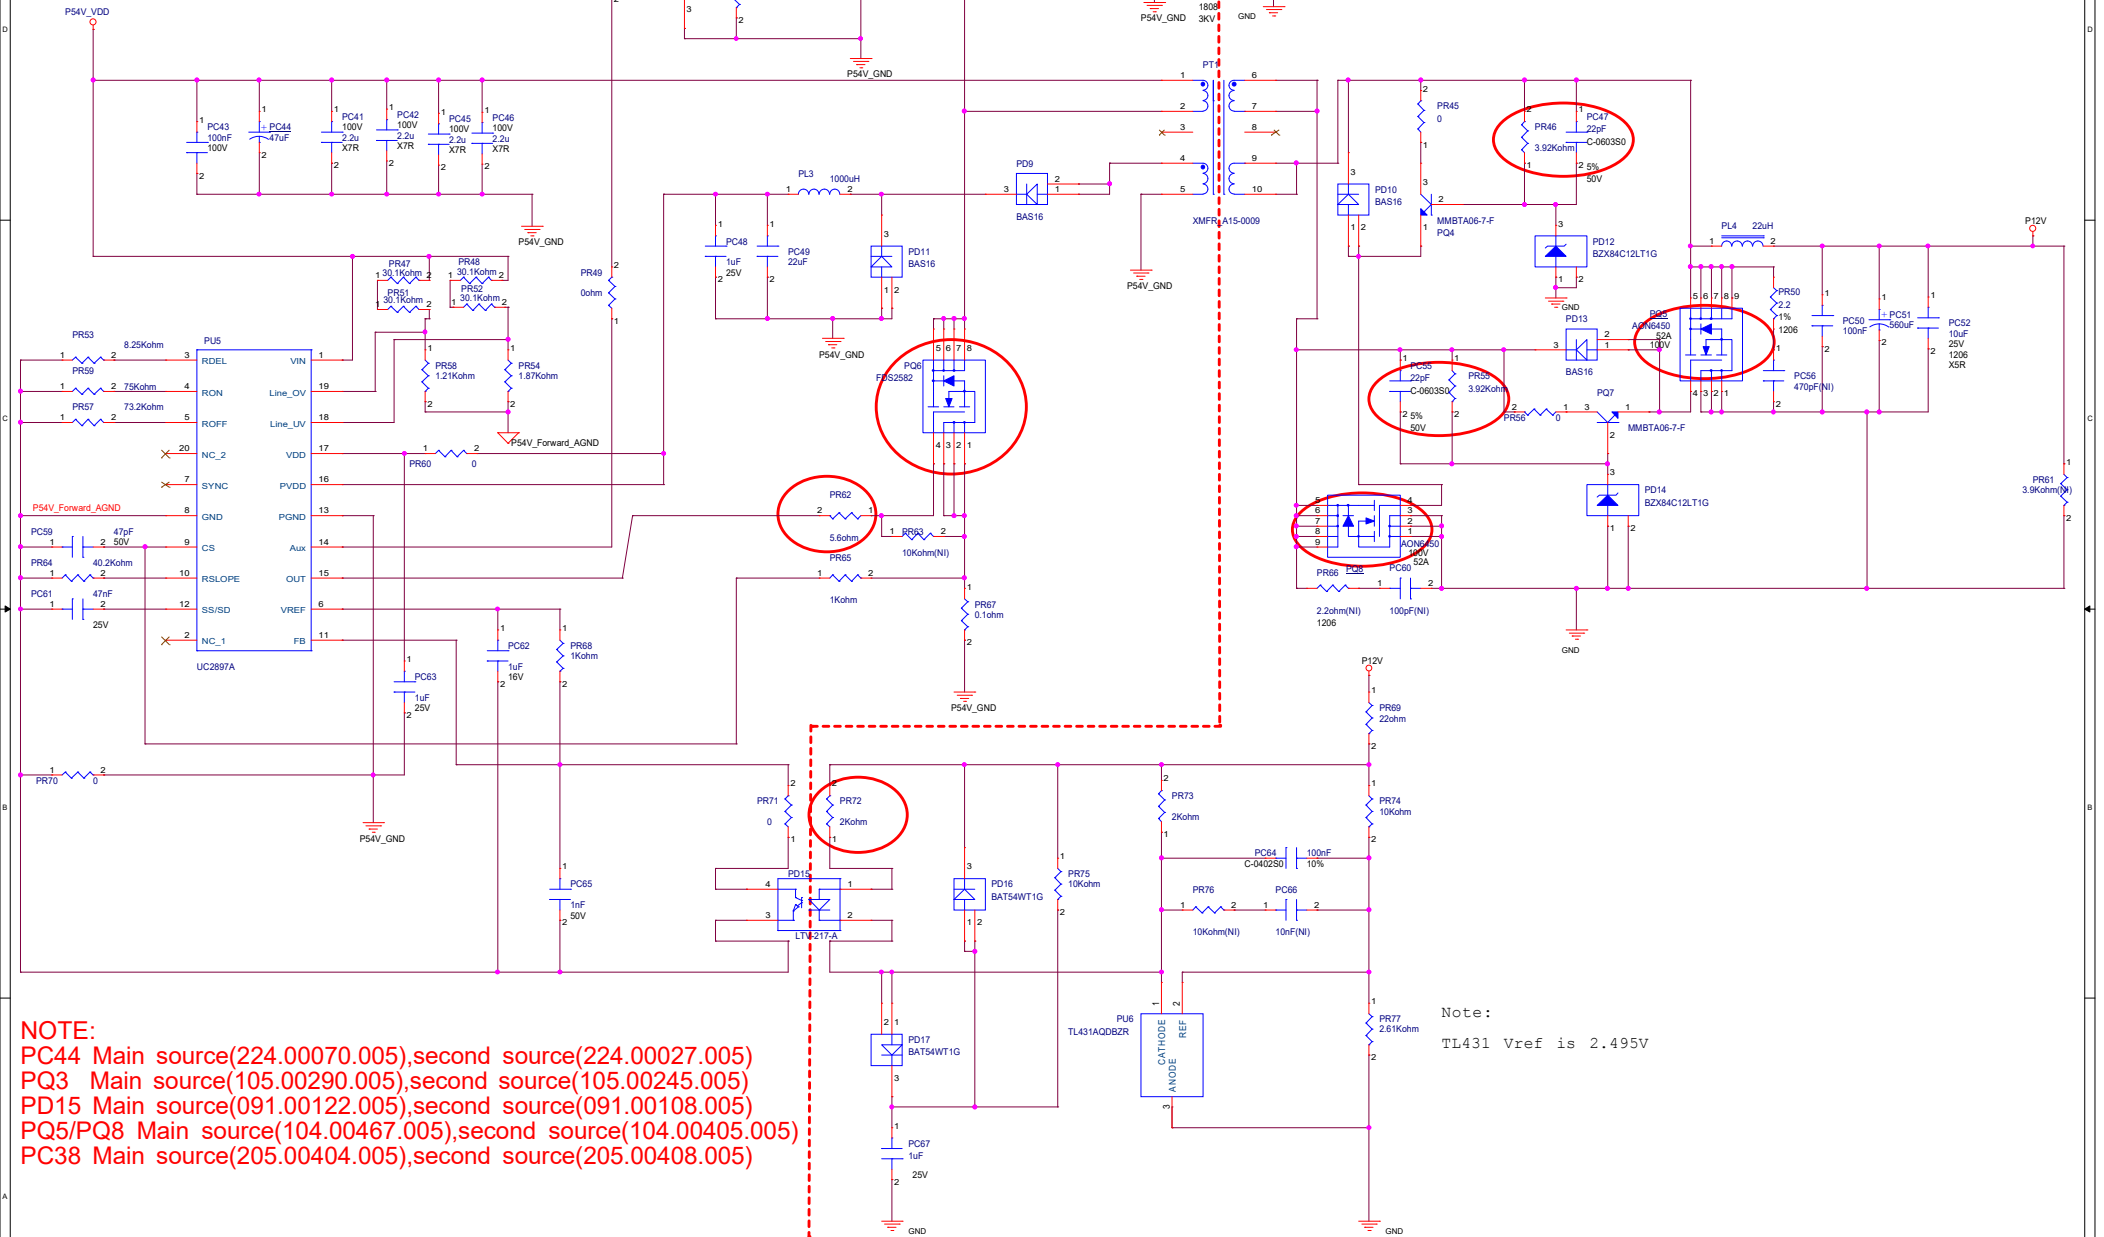
PT1 is EP13 Transformer, need to double check layout footprint
